Report to the Sydney Eastern City Planning Panel

COUNCIL ASSESSMENT REPORT

Panel Reference	PPSSEC- 102
DA Number	DA-533/2017/1/A
LGA	Waverley Council
Approved Development	Demolition of buildings and the construction of a 10 storey mixed use building including 78 residential apartments, ground level retail, a registered club at ground and first floor levels and three levels of basement parking
Proposed Modification	Section 4.56 modification to approved layout and façade, increase number of apartments from 78 to 81, increase in floor space, divide retail tenancies, delete rooftop pool and provision of an outdoor cinema, and enlarge and alter roof top plant area
Street Address	28-42 Bronte Road and 84 Ebley Street, Bondi Junction
Applicant/Owner	Lucy Ford, C/- Capital Corporation Bondi Pty Ltd/ Bondi Junction-Waverley RSL Sub Branch Club Ltd
Date of DA lodgement	1 October 2020
Number of Submissions	6 submissions
Recommendation	Approval
Regional Development Criteria (Schedule 7 of the SEPP (State and Regional Development) 2011)	Section 4.56 modification application of development consent granted by the Land and Environment Court for a development with a CIV of more than \$30 million

Figure 6: Comparison Plans showing changes in setbacks proposed

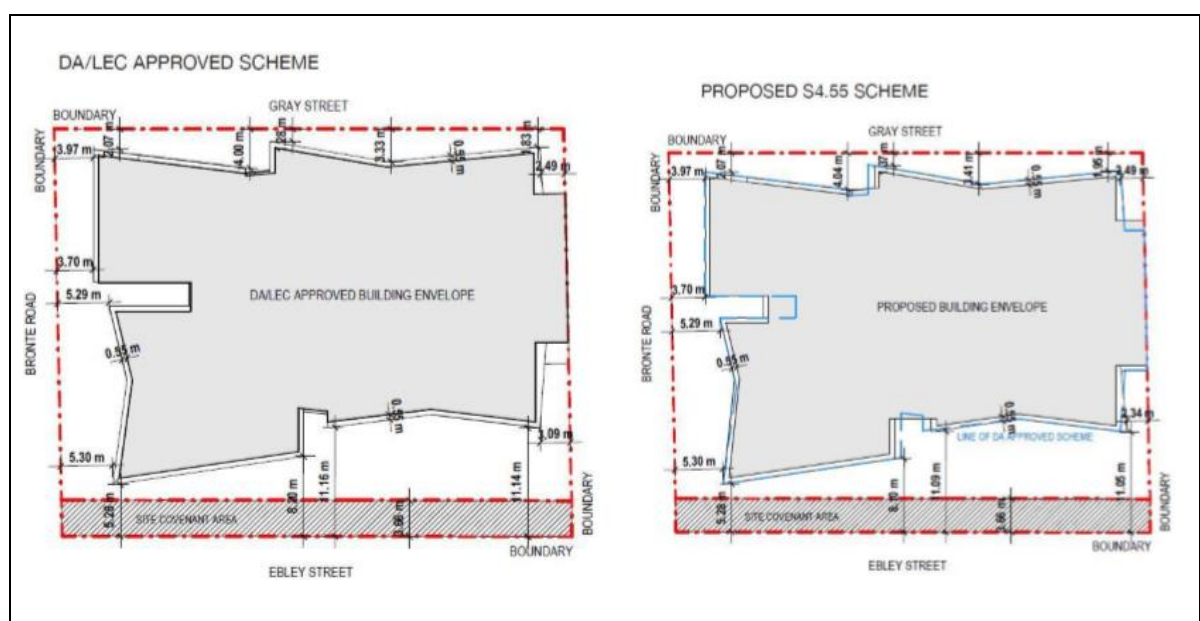
Assessment was undertaken during the consideration of the original application approved by the LEC of proposed separation distances for the subject building and impacts on the amenity of its occupants. Minor changes are now proposed to the setbacks proposed at each elevation which are demonstrated in the comparison drawings below at **Figure 6**.

The approved development achieved setbacks ranging from 2.4m to 7.2m along Bronte Road, and 5.9m to 13.0m along Ebley Street from the boundary. Level 2 is further setback to assist in separating the podium from the upper tower form. The modified design involves a series of minor updated setbacks. The fundamental urban design principles however remain unchanged. The proposed new setbacks are considered to be generally consistent with what was approved, with the minor changes proposed not being readily discernible when viewed from the street or surrounding buildings. The proposed new setbacks also do not result in unreasonable impacts on the amenity of nearby properties from overshadowing, view loss, visual bulk and scale or visual and acoustic privacy. The modified setbacks can be supported.

Figure 9: Comparison roof plan showing modification to approved plant area (previous approval scheme on left, proposed scheme on right)

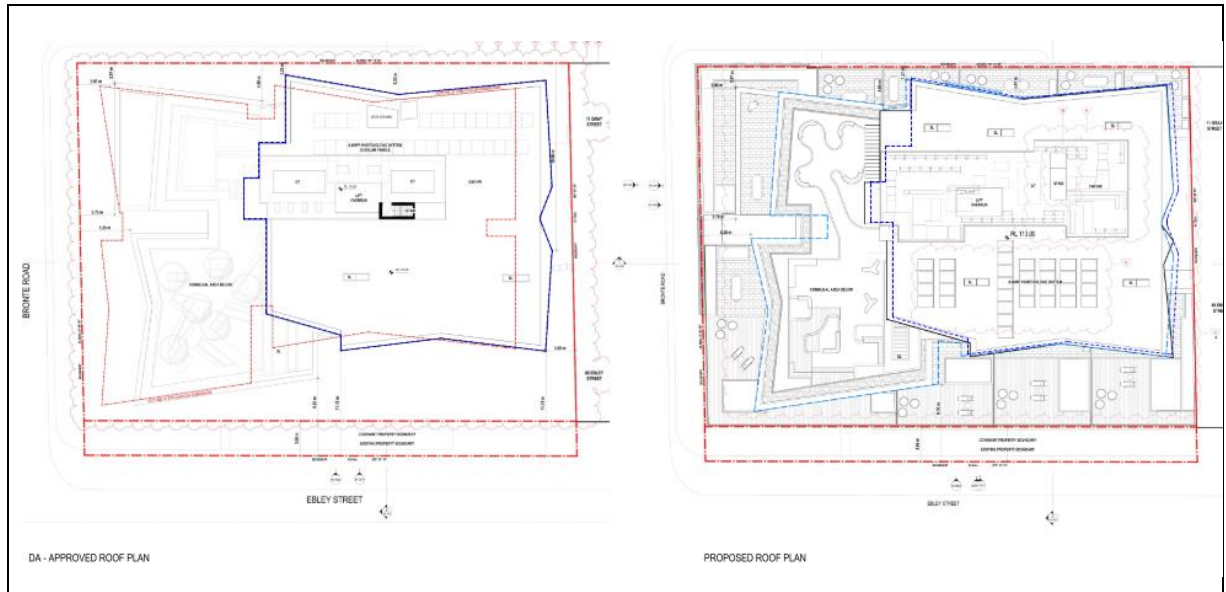
The subject modification application does not seek to increase the height but seeks to extend the area of plant and equipment proposed to the roof area from 130m² to approximately 240m² in area plus add photovoltaic panels. The main roof plant area will run east-west along the central length of the roof (refer to **Figure 9** below). The applicant advises that the plant area is required to accommodate the cooling tower for the RSL club space, mechanical pumps, mechanical boilers for heating system, residential condensers which are to be double stacked to minimise footprint, air supply intakes and air exhaust outlets.

The applicant has submitted a Mechanical Services Concept Design Report prepared by Intrax Mechanical Engineers dated 22 July 2020 with the modified application outlining the service requirements for the development. A further supporting document from Intrax projects, dated 3 February 2021 was submitted to Council on 10 February 2021 stating:

The mechanical systems on the roof top in the Development Application submission were concept only. During the design development phase it has become apparent that the roof plant space was inadequate and the current proposed roof top plant is required to conceal all mechanical services for the building.

The increase in the area proposed to accommodate the building's plant and equipment under this modification application is as a result of the design resolution in relation to mechanical servicing of the building which is not unusual for a development of this scale at Construction Certificate stage.

Figure 11: Comparison south elevation showing modification to approved plant area as viewed from Ebley Street frontage (previous approval scheme on left, proposed scheme on right)

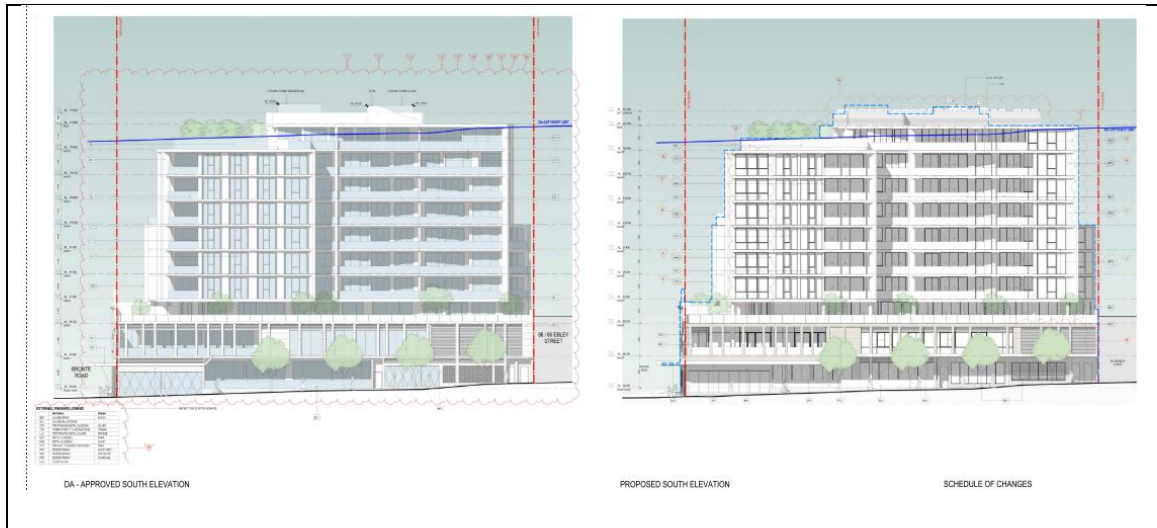
The increase in the roof plant area does not change the overall appearance of the approved development when viewed from the street. There will be no unreasonable impacts on the amenity of nearby properties as a result of overshadowing, view loss, visual or acoustic privacy. The proposed modifications to the roof plant area are considered to be acceptable and can be supported.

Figure 13: View towards subject site (to the far left) from RL115.75 eye level standing at mid tower level of Eastgate West Tower showing DA approved envelope (source: applicant's submission)

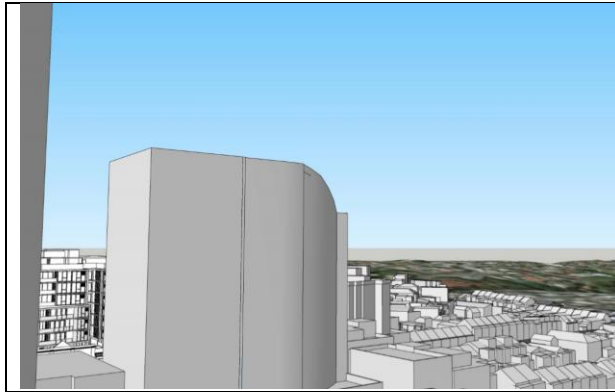
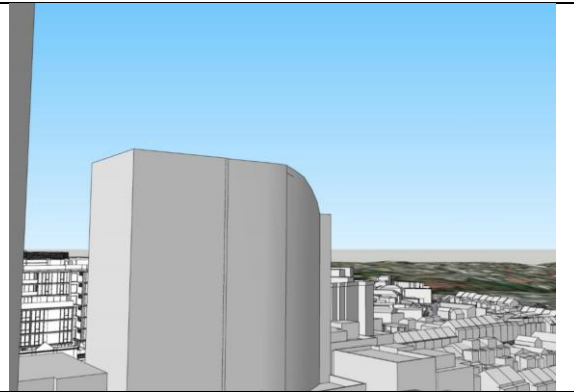
The above images demonstrate that there will be no unreasonable view loss impacts from nearby properties as a result of the extended roof plant area. Accordingly, the proposed development and corresponding view sharing arrangements are considered reasonable and are an appropriate response
